# Service Bulletin N° 97

SUBJ: X-Wing Motor Bushing

Fig. 1

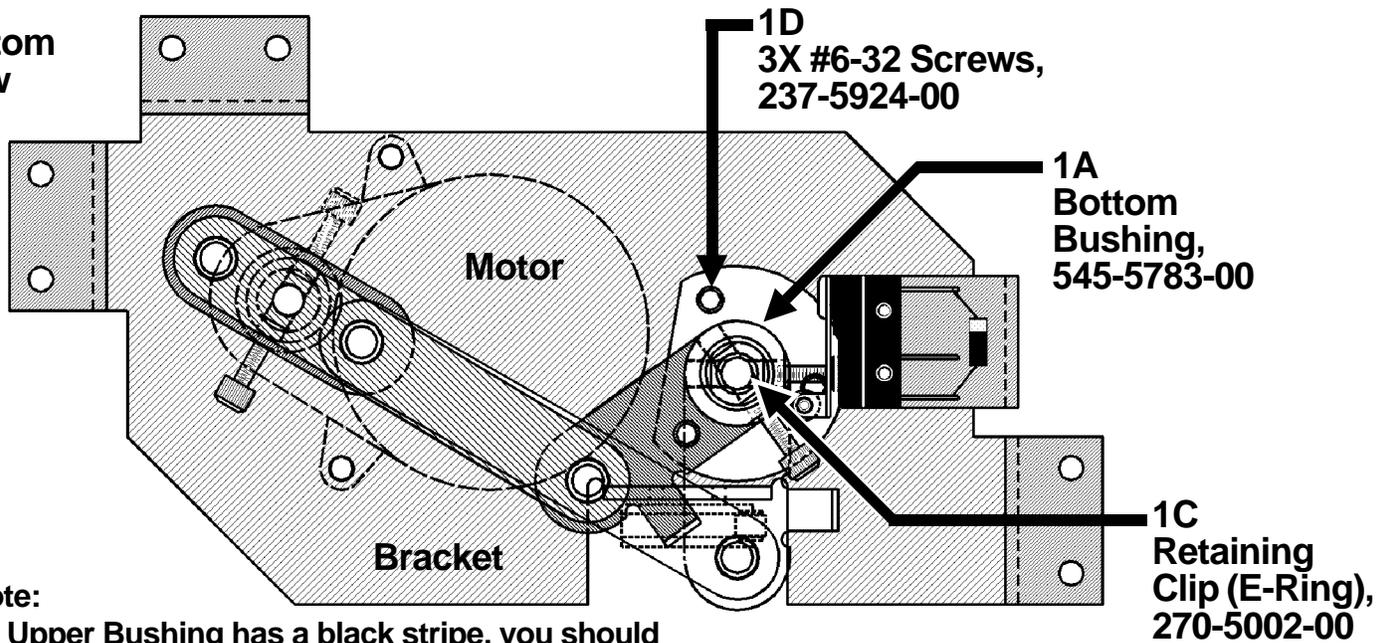
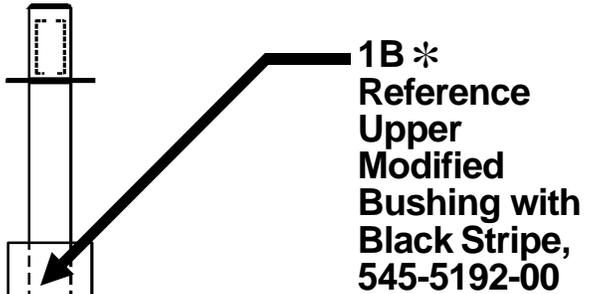
Sometimes at the start of the X-Wing Multiball Feature with the ball loaded into the Cannon, the X-Wing Assembly may not move. This does not necessarily mean the motor has failed; it is simply in a "stuck-state." The *slightest tap or nudge* to the game will start the X-Wing to move again. **If you should experience this symptom please refer to the procedure below.**

Due to slight variances in spotting the X-Wing Assembly while mounting it to the playfield, the shaft bushings (**See Fig. 1**) can cause some binding to the motor shaft. Increasing the inside diameter of *either* shaft bushing (**See Fig. 1A & 1B**) will correct this problem. For simplicity in this correction we recommend fixing the bottomshaft bushing (**See Fig. 1A**). (**See Note below.**)

\* Note:  
If the Upper Bushing has a black stripe, you should not experience any "stuck-state" symptom and no further update procedure should be required.

- ① Locate the X-Wing Motor Assembly Bottom Shaft Bushing, 545-5783-00, on the bottom side of the playfield (**See Fig. 1A**).
- ② Locate and remove the Retaining Clip (E-Ring), 270-5002-00, located at the base of the X-Wing Shaft (**See Fig. 1C**).
- ③ Remove the three (3) #6-32 X 1/2" HWH TF Mounting Screws, 237-5924-00, securing the Bushing to the X-Wing Motor Bracket (**See Fig. 1D**).
- ④ Remove the Bushing from X-Wing Motor Bracket (**See Fig. 1A**). Using a #G or a 6.6mm Drill Bit, enlarge the existing Bushing Shaft Hole. Reassemble.

As stated, there are 2 X-Wing Shaft Bushings, one (1) on the X-Wing Motor Assembly (**See Fig. 1A**) and one (1) on the Upper Motor Shaft on the playfield side (**See Fig. 1B**). **All games made after Serial N° 138041 have been modified and should not experience this "stuck-state" symptom.** The bushing mounted on the playfield side will have a black stripe indicating this (**See Fig. 1B**). **Unless your game is experiencing the above symptoms disregard the above procedure.**

If you do experience the "stuck-state" symptom, simply remove the bottom shaft bushing (removal of the Retaining Ring & 3 Screws is required) and drill the existing Shaft Hole with a #G or 6.6mm Drill Bit and reassemble.
